HISTORIC AND DESIGN REVIEW COMMISSION

HDRC CASE NO: 2019-060
ADDRESS: 223 LAUREL HEIGHTS PLACE
LEGAL DESCRIPTION: NCB 6328 BLK 1 LOT 50 & S IRRG 121.2 OF 49
ZONING: R-5,H
CITY COUNCIL DIST.: 1
DISTRICT: Monte Vista Historic District
APPLICANT: PAM CARPENTER/Seventh Generation Design, Inc.
OWNER: Gary & Theresa Poenisch
TYPE OF WORK: Construction of a 1-story accessory structure, landscaping and hardscaping
APPLICATION RECEIVED: October 18, 2019
60-DAY REVIEW: December 17, 2019
CASE MANAGER: Stephanie Phillips
REQUEST:

RE: 223 Laurel Heights Place – Final Approval Application Written Narrative

1 PROPOSED CARPORT SITE PLAN

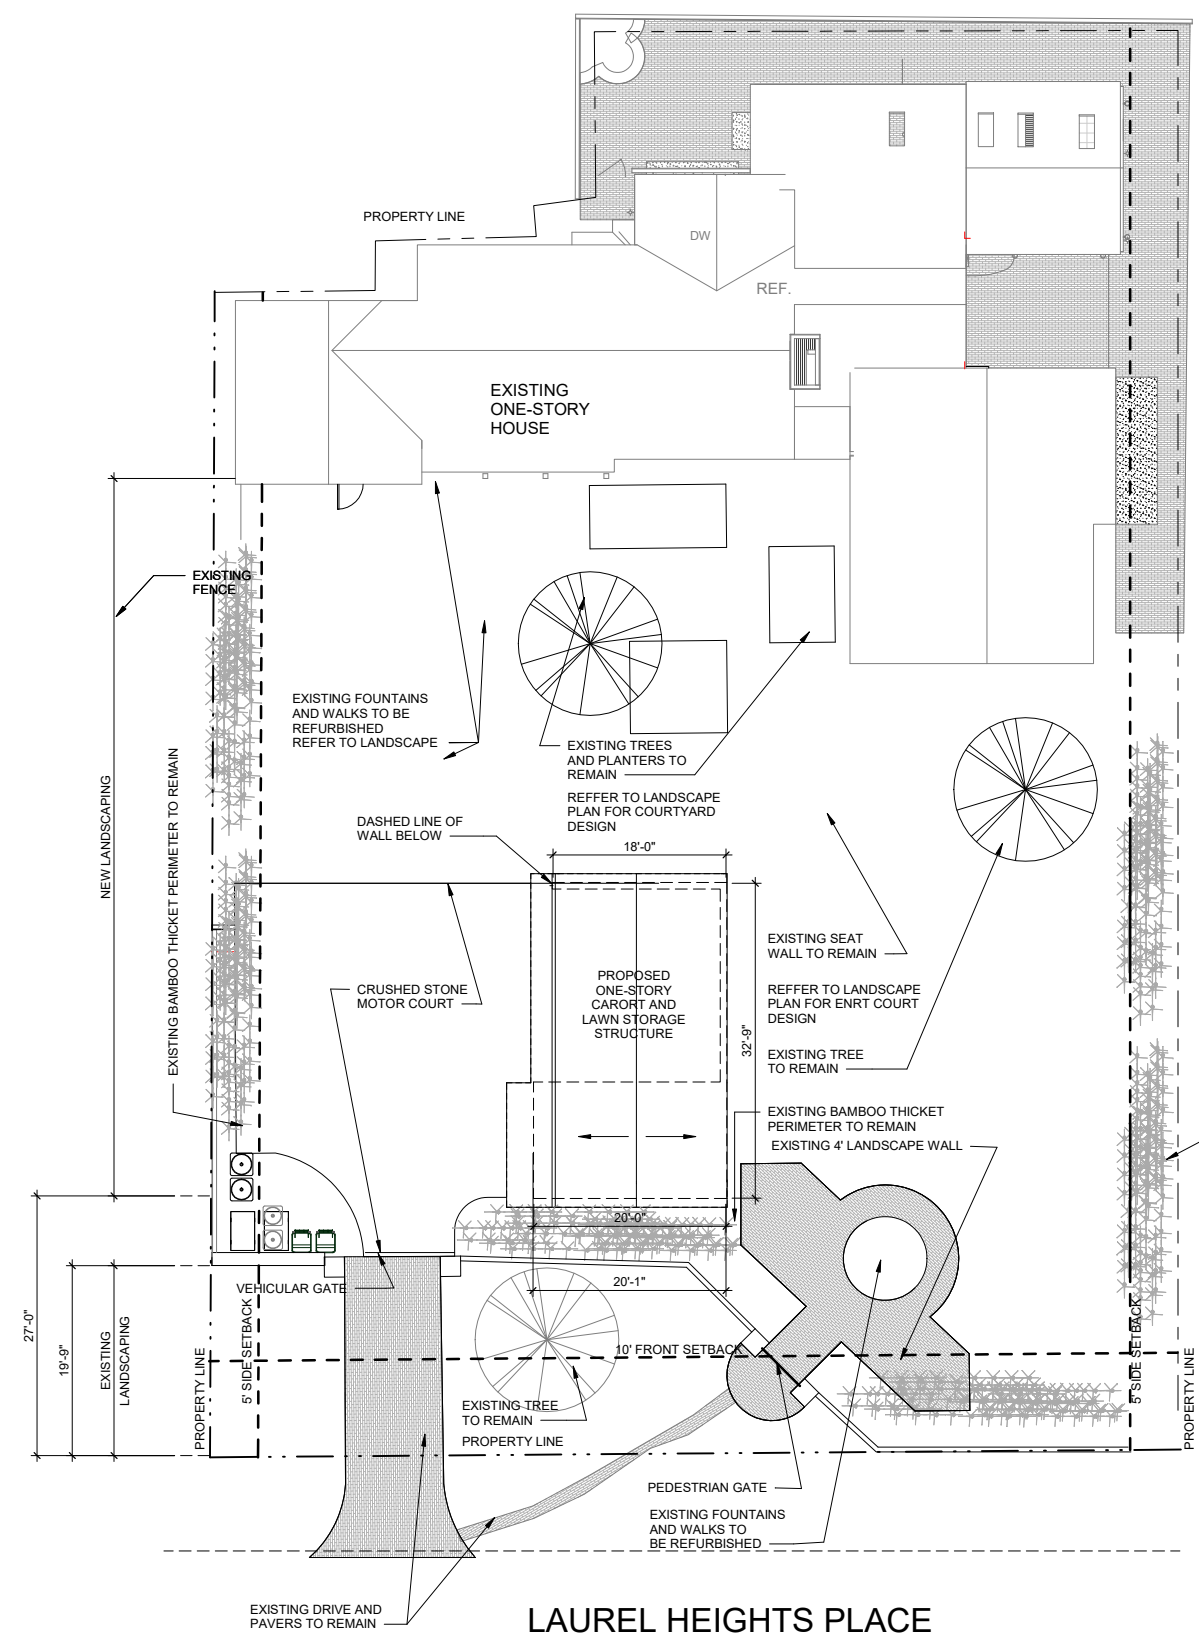
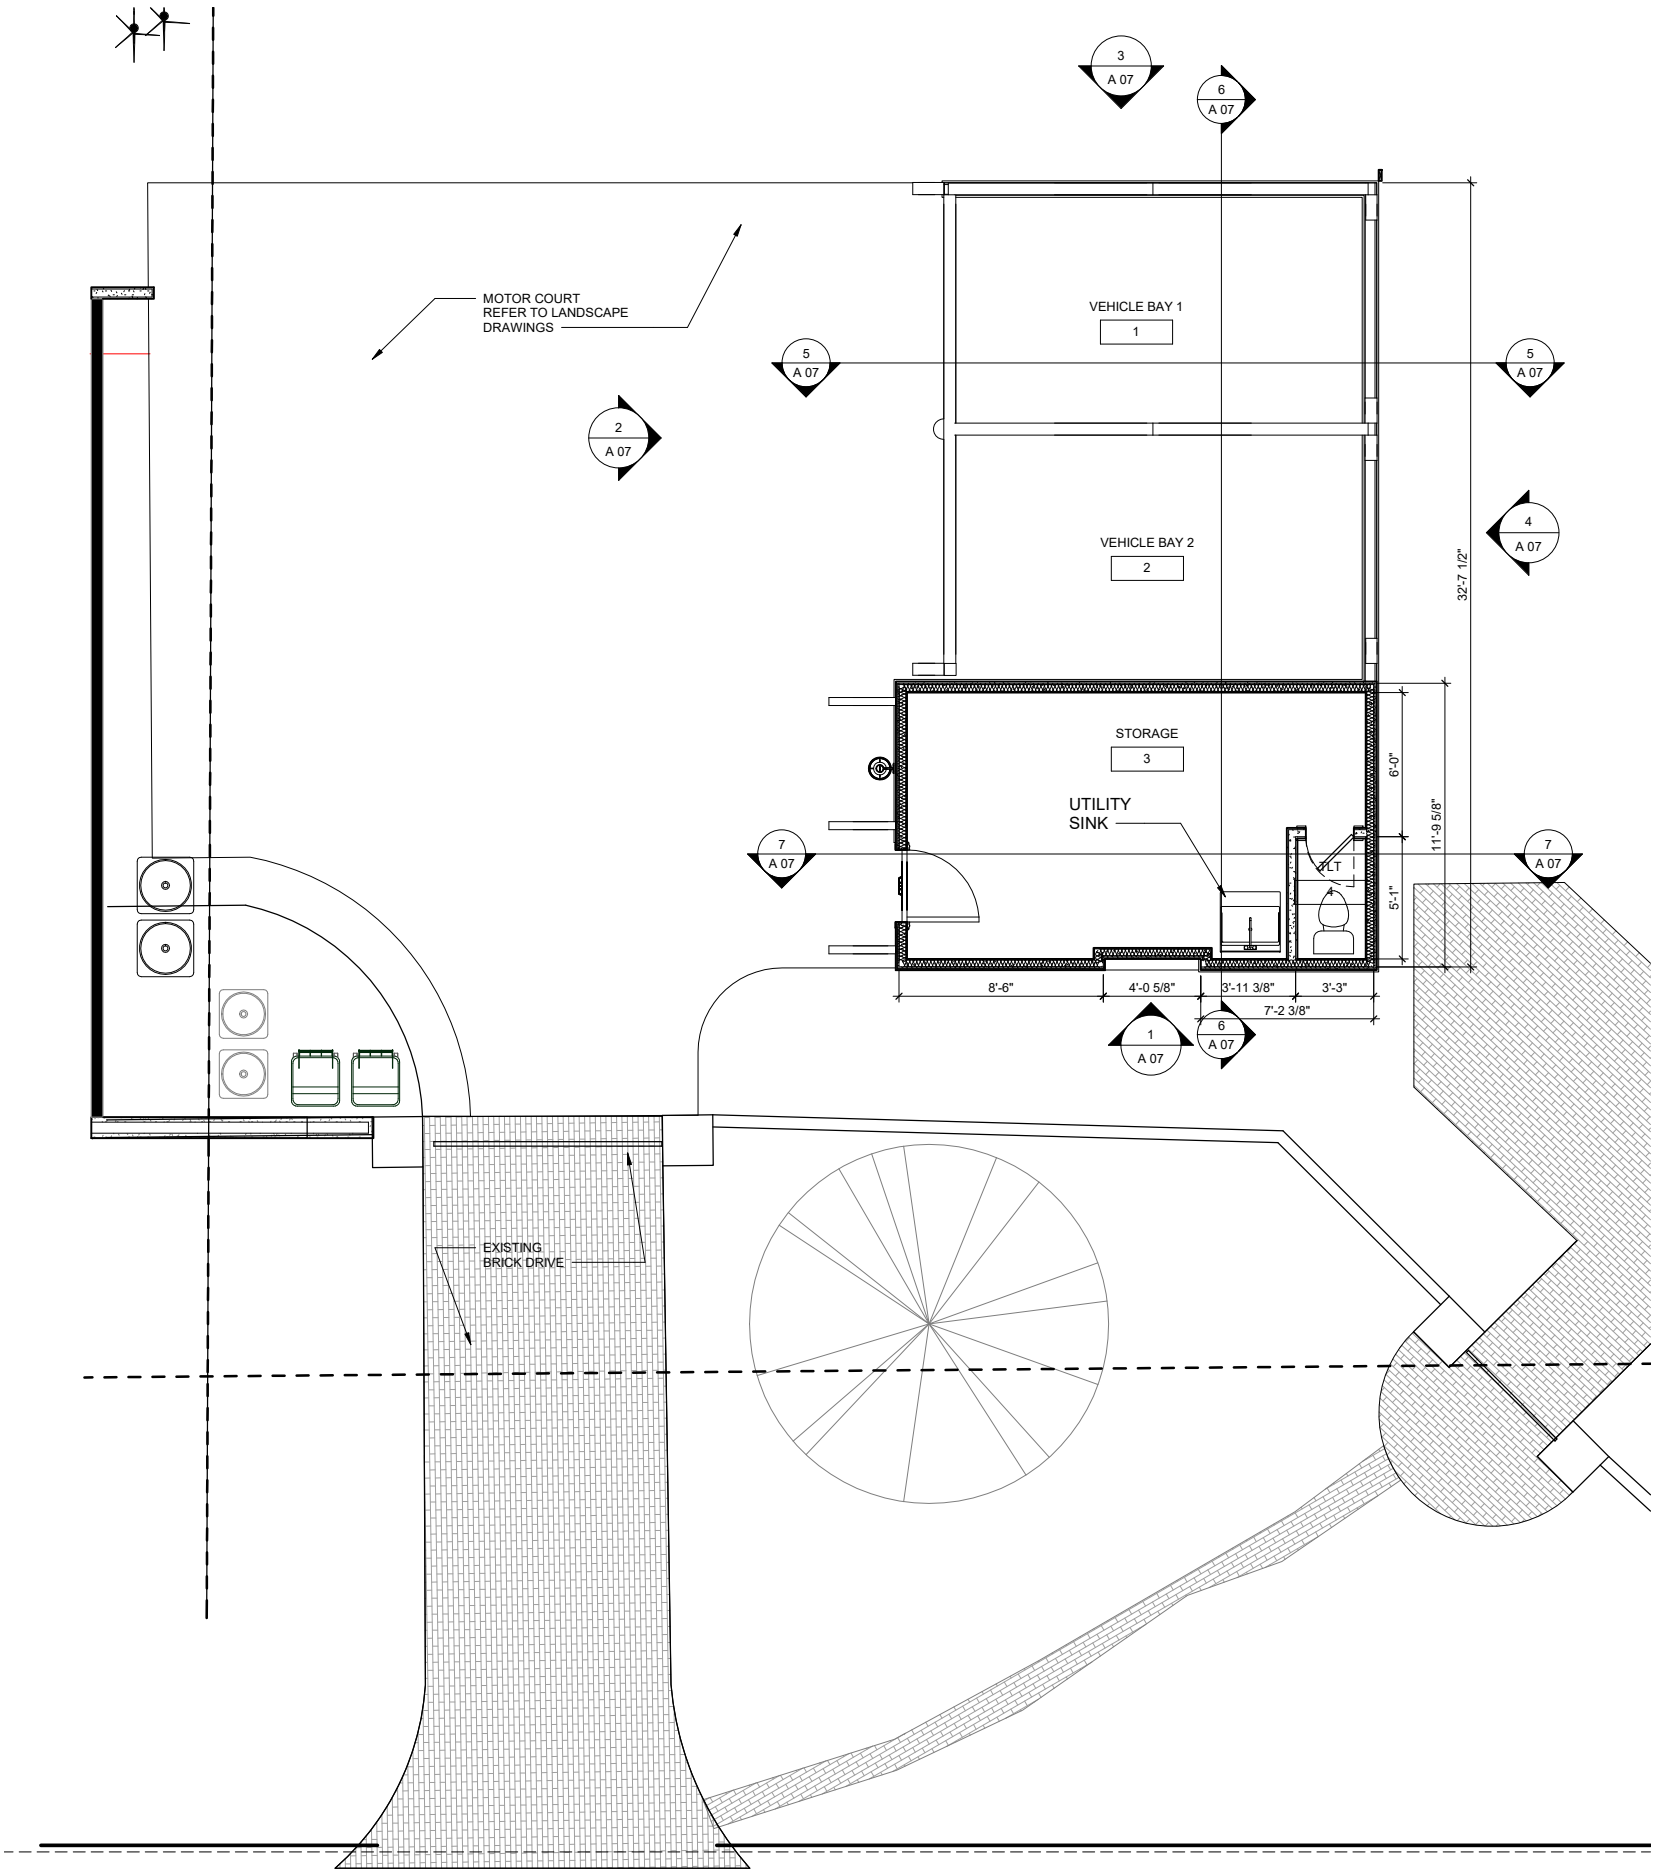
- e. ORIENTATION & SETBACK – Guidelines 5.B.i and 5.B.ii for new construction state that new garages and outbuildings should follow the historic development pattern and feature orientation and setbacks common in the district. The applicant has proposed to construct the carport and storage structure in the front yard of the property with a front setback of approximately 27 feet. Generally, historic accessory structures and outbuildings were commonly located at the rear of the property. The development pattern of the Monte Vista Historic District follows this pattern overall. However, the development pattern of Laurel Heights Place deviates from the consistent pattern of the district east of McCullough. This property features a significant setback and the footprint of the primary structure spans the width of the lot. The front of the lot has likely been utilized as motor court since the home was constructed. The lot also features a stucco wall along the street frontage and significant landscaping that screens the motor court area from public view. Based on these site-specific considerations, staff finds the orientation and setback appropriate.

- k. LANDSCAPING – The applicant has proposed various landscaping modifications to the front yard adjacent to the proposed carport and storage structure. The proposal includes a semi-pervious paving strategy to replace existing impervious concrete cover, an open green lawn, courtyard, and axial design with parterre garden. Existing planters and seat walls will be retained. The proposed planting scheme includes flowering native perennials, mountain laurel, sumac, and beauty berry. Staff finds the proposal consistent.

Exterior Elevations &
Sections

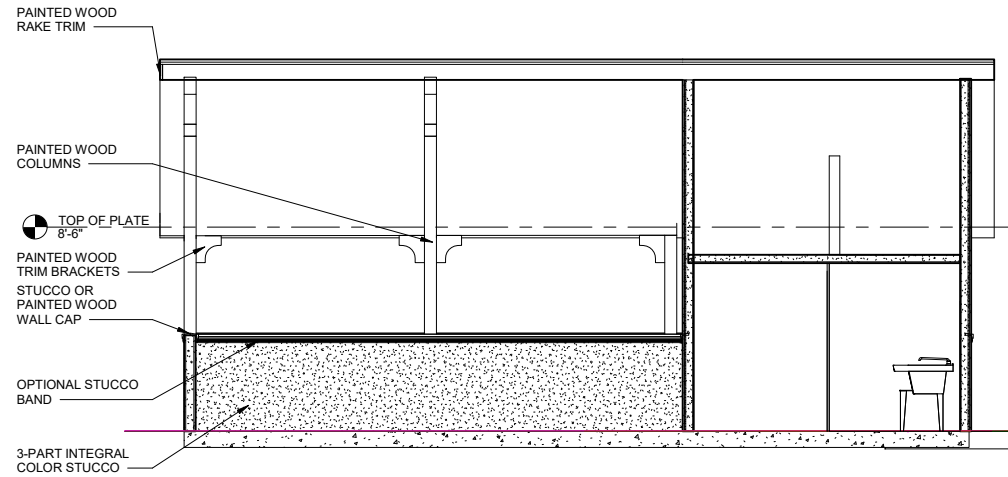
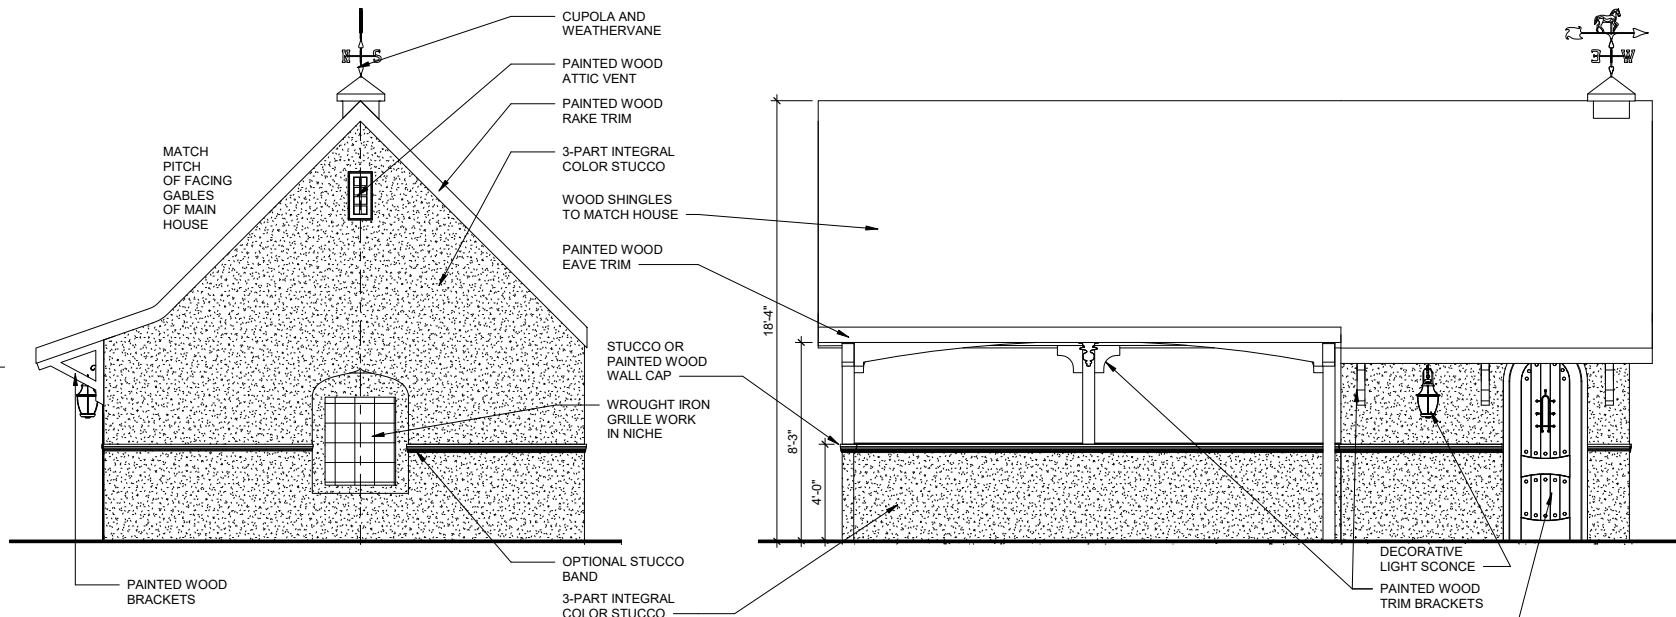
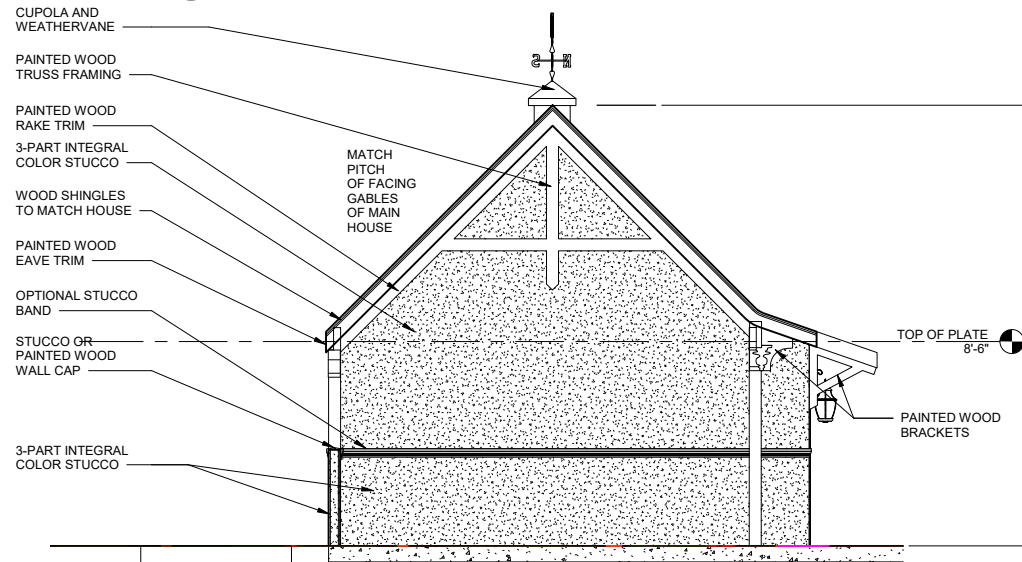
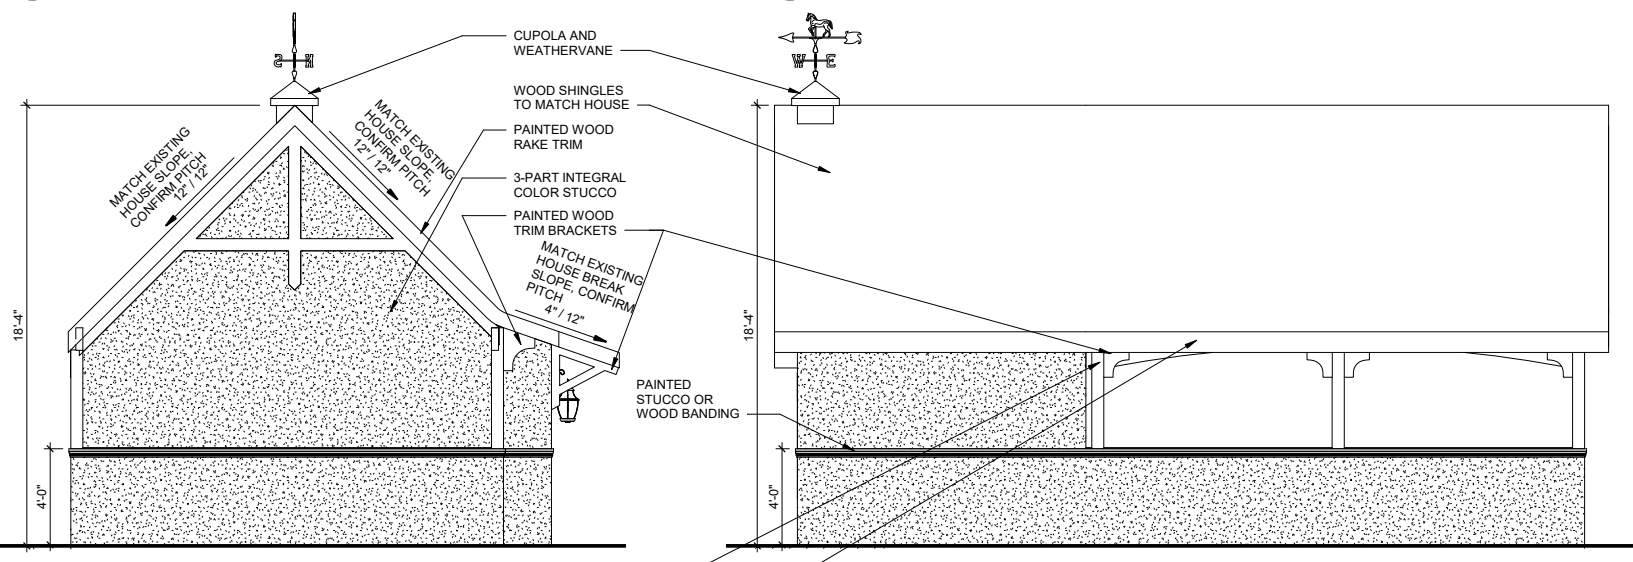
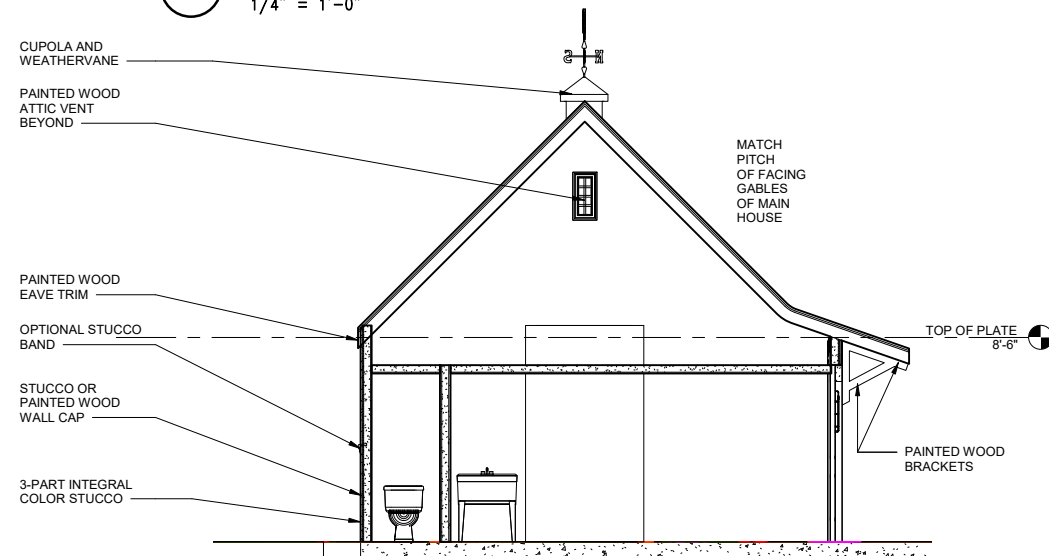
- g. ROOF FORM – The applicant has proposed a primary gable roof form with decorative wood trim to match the primary structure. The roof will be constructed of wood shingles to mimic the existing structure. Staff finds the proposal appropriate.

- h. FENESTRATION – The applicant has proposed to install a stained wood door on the west elevation adjacent to

the carport openings and a window opening on the south elevation. The opening will feature inset wrought iron grille work. According to the Historic Design Guidelines, windows and doors used in new construction should feature traditional materials or appearance. Staff finds the proposal appropriate.

- j. ARCHITECTURAL DETAILS – The applicant has proposed various Tudor Revival-inspired exterior wood details, including truss and bracket detailing. According to the Guidelines, architectural details of new construction should keep with the predominant architectural style along the block face or within the district when one exists. Details should also be simple in design and should complement, but not visually compete with, the primary structure or adjacent structures. Staff finds the proposal consistent with the Guidelines.
